YR-2022/452 - 20 DAVID HILL ROAD, MONBULK- PLANNING REPORT

| Application No. | YR-2022/452 |
| Proposal | Use and development of the land for a childcare centre, removal of vegetation, display of business identification signage and reduction in car parking |

Figure 10 - Proposed Signage Plan

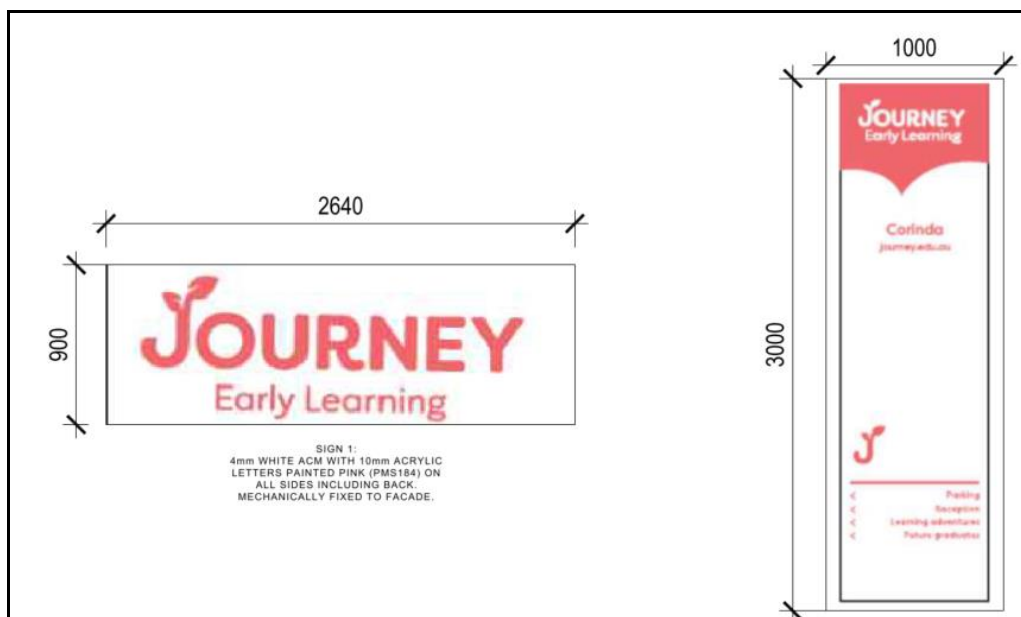
The application for two (2) business identification signs is deemed excessive in number and proposed size for the use and is considered to be incompatible with the local road's street character.

To achieve an acceptable outcome, it is recommended Sign 1 (the smaller sign) is removed and Sign 2 (the free-standing pylon sign) is reduced to two (2) metres in height. The recommended permit conditions will achieve these changes.

Figure 11 - Proposed tree removal

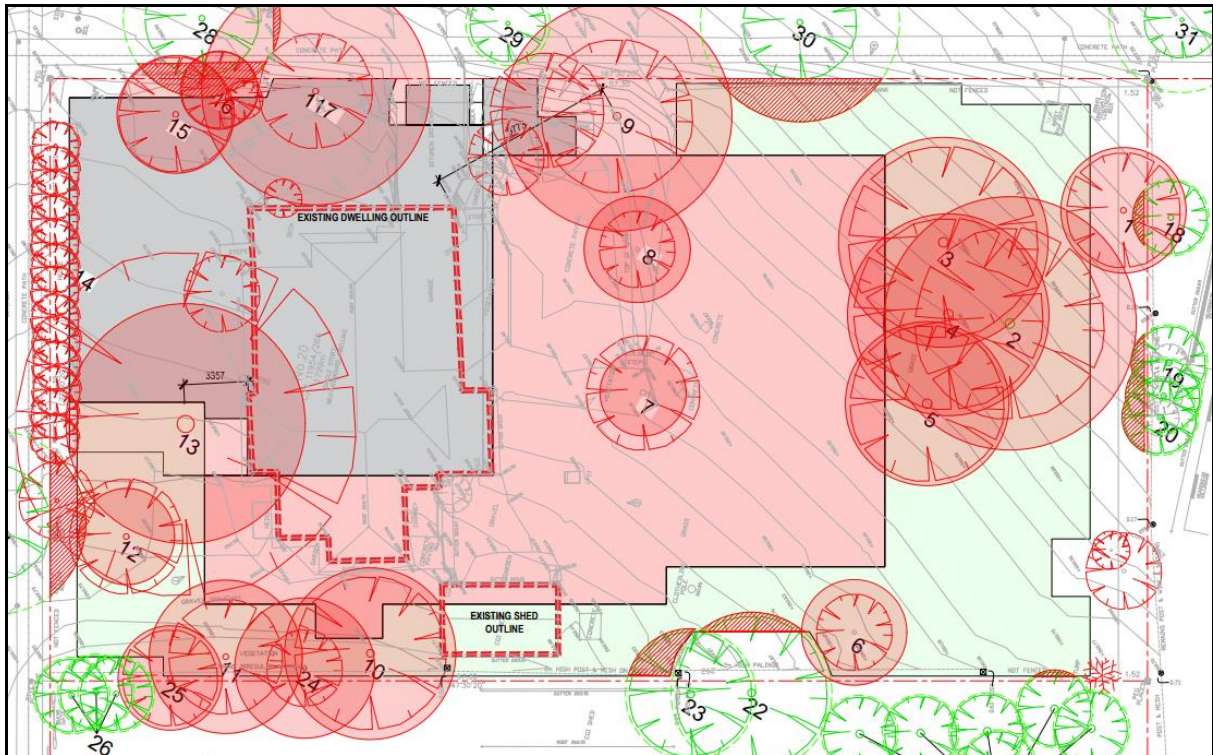
A number of the proposed nominated trees for removal are located centrally on site (not close to boundaries) and are of low retention value. The proposed use has specific design and function requirements that require the trees to be removed. A balanced approach therefore needs to be considered as to which is more important, the childcare centre or protection of trees.

By supporting the proposed use and development essentially gives less weight to tree retention. Unfortunately, the trees nominated for removal are not capable of being retained. To offset this loss, the proposal provides landscaping provisions around the site perimeter. In the medium to long term, the replacement vegetation planting proposed on the landscape plan will achieve a similar level and quality of landscaping as presently exists.

Figure 12 - Acoustic barriers (Source - Acoustic report)

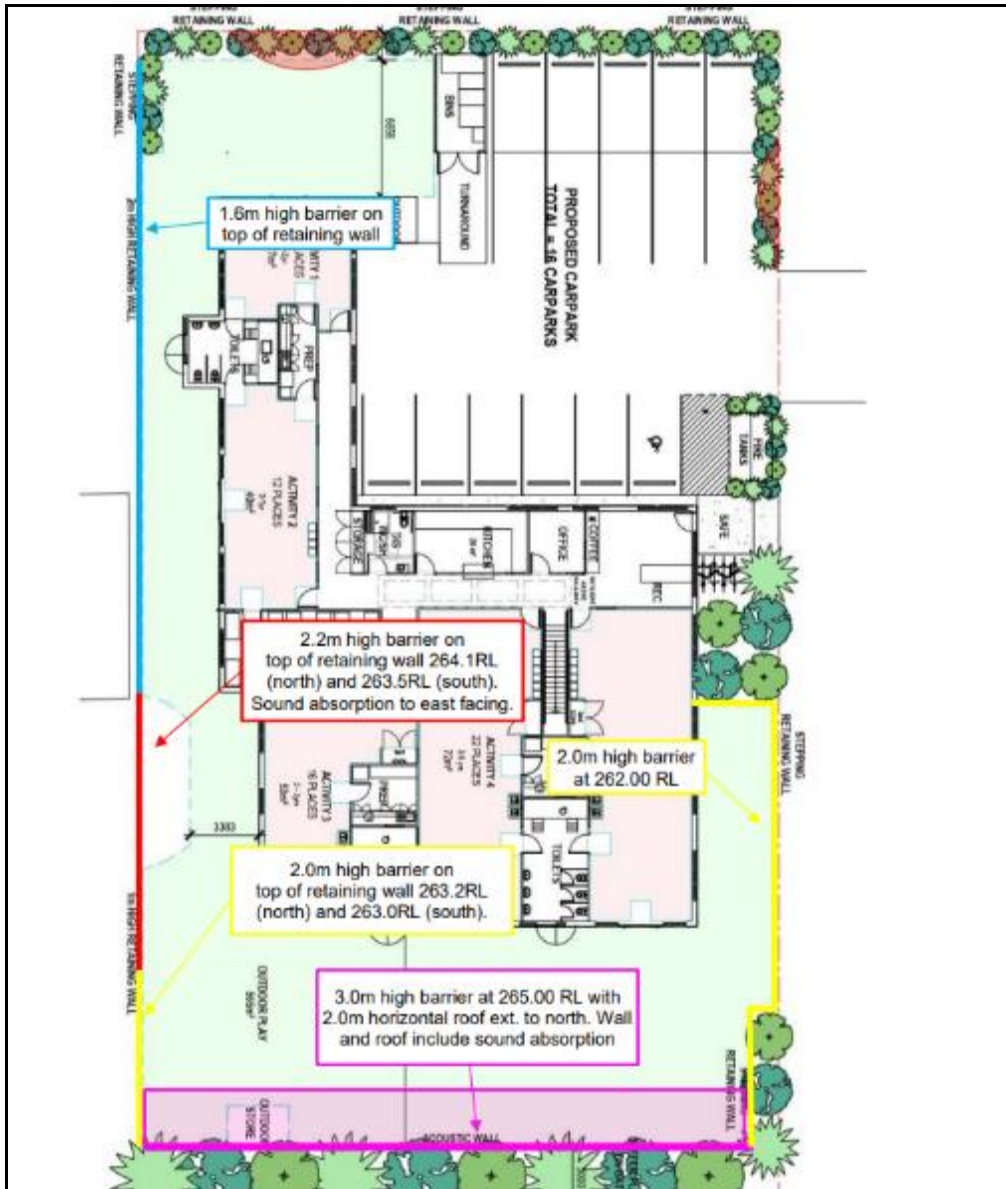
The assessment and recommendations outlined in point 10.6 of the Acoustic Report, states the need to install acoustic barriers around south, east and west perimeter of the site, to be made of and to particular material specifications (See Figure 12). Installation of acoustic barriers would also assist in resolving objector's noise amenity impacts concerns.

A three metre high acoustic wall with a cantilevered two metre wide fin along the southern elevation is recessed three metres from the title boundary and is to be buffered by dense evergreen landscaping. The structure height is not dissimilar to what is ordinarily found in residential areas, for a veranda or alike. The structure height is necessary to curb noise for the neighbouring elevated dwelling (Figure 12).

The proposed development plans do not clearly illustrate what is required to achieve this. A condition has been included to secure clearer notations on the development plans to show this detail.

Figure 13 - Static water supply for fire-fighting purposes

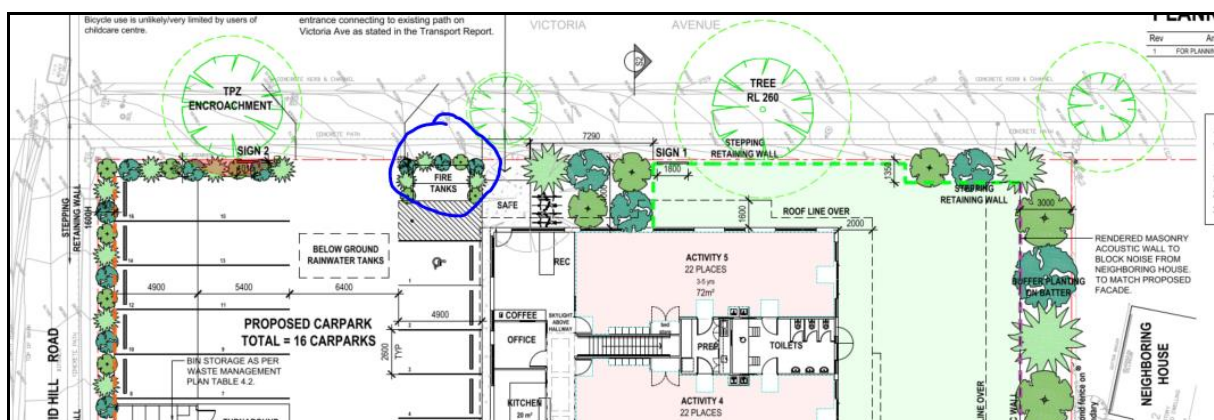
The static water tanks sited along eastern boundary will need to be suitably treated to ensure they are properly screened by either vegetation or a hard screen. A condition has been recommended to be placed on any permit granted to obtain an updated landscape plan that takes this into account.
